**JULY 16, 2013 ZONING HEARING
"OTHER BUSINESS"
COMMISSION DISTRICT 1**

To consider approval of an R-20 Open Space Community Overlay application for The Pacific Group, Inc. regarding Application OSC 13-02 filed May 6, 2013, for property located southwesterly side of Stilesboro Road; west of New Salem Road; east of Kennesaw Due West Road in LL's 241 of the 20th District, Cobb County, Georgia.

PETITION NO: OSC 13-02

Figure 1 Project Area and Cultural Resources Location Map

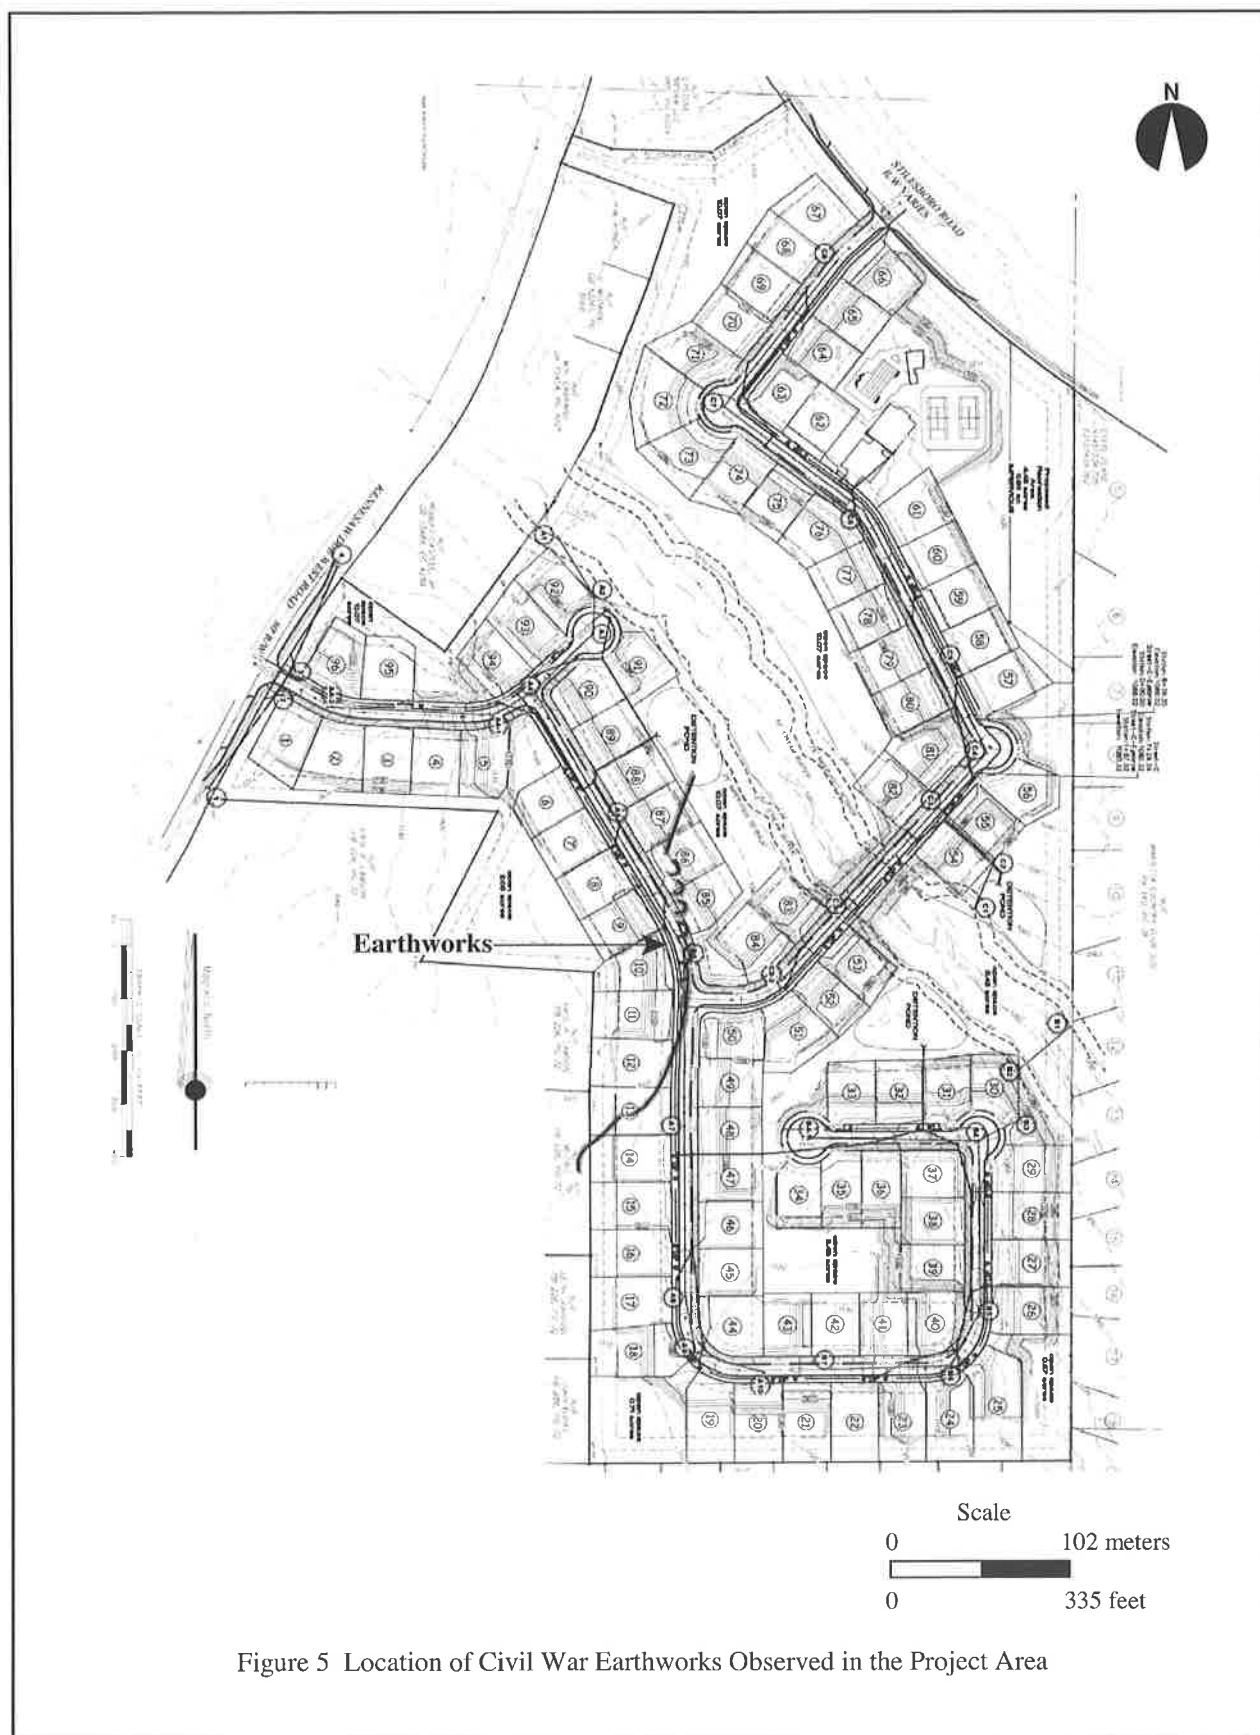
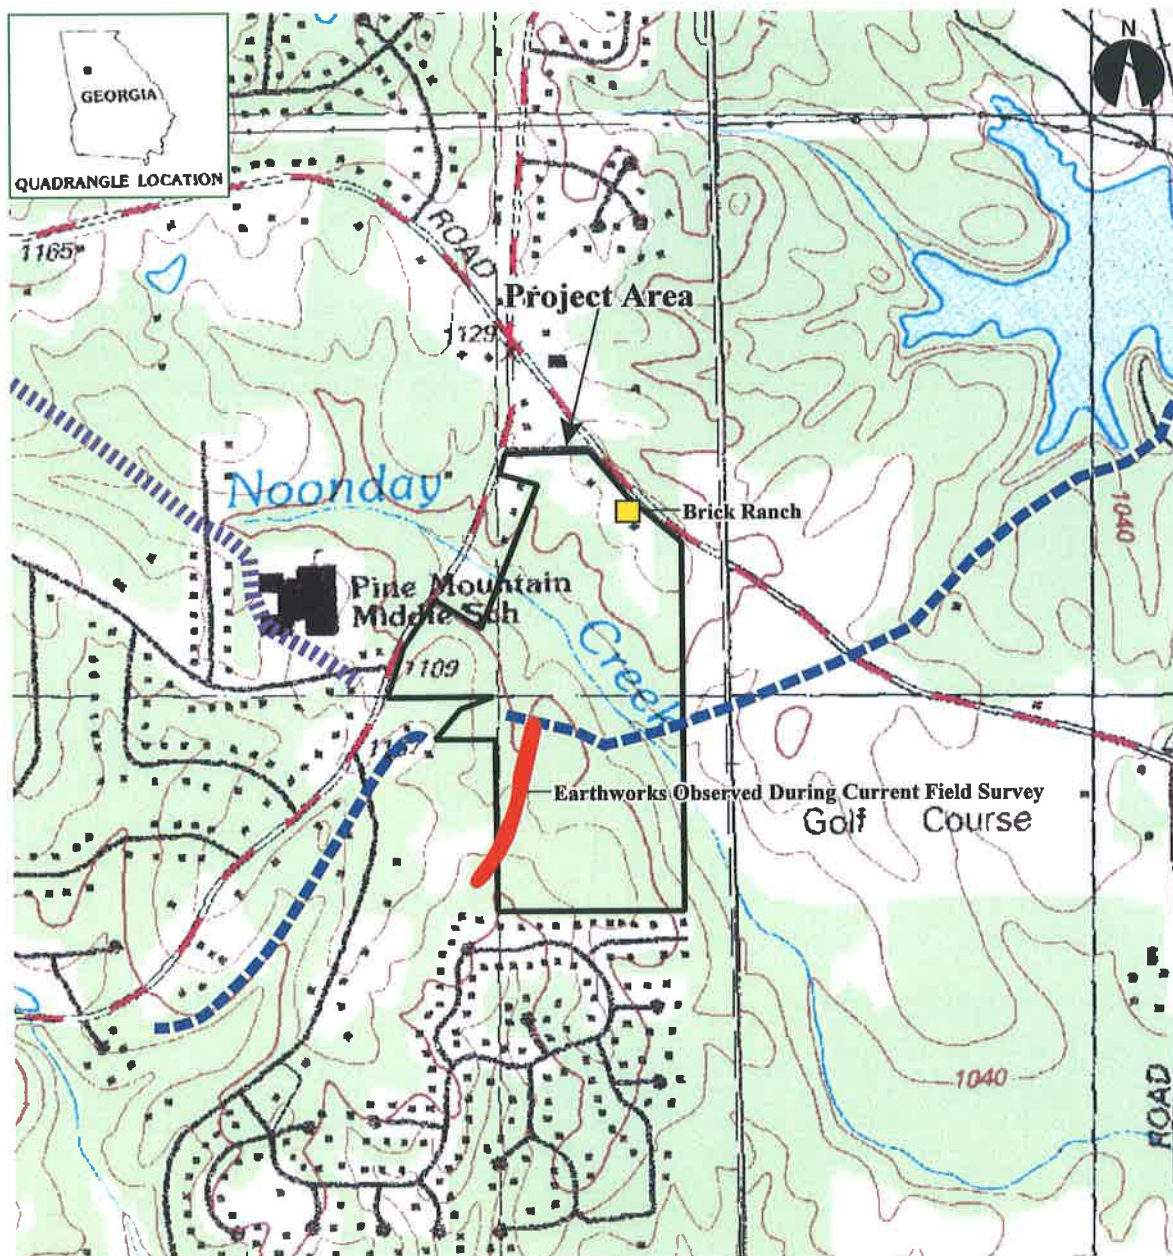
1. Lots 82 and 92 should be completely above Floodplain
2. Civil War earthworks have been observed on site. Please provide a plan that depicts location, orientation and type of earthworks that exist on property and include the historic area to be protected within the required Open Space unless other measures have been agreed upon.

The plan appears to properly account for the 100-year floodplain and stream buffers on the site. However, I do not think that the straight R-20 plan is a valid one, since it does not account for area needed for detention. If you overlay the detention ponds shown on the OSC layout you would have to eliminate lots 77, 78, 89 & 90 and parts of lots 44, 45, 46 & 47. Also, several lots do not have the necessary 12,500 sf minimum area above the floodplain to be buildable. These include lots 75, 76, 77, 80, 81, 82 & 83.
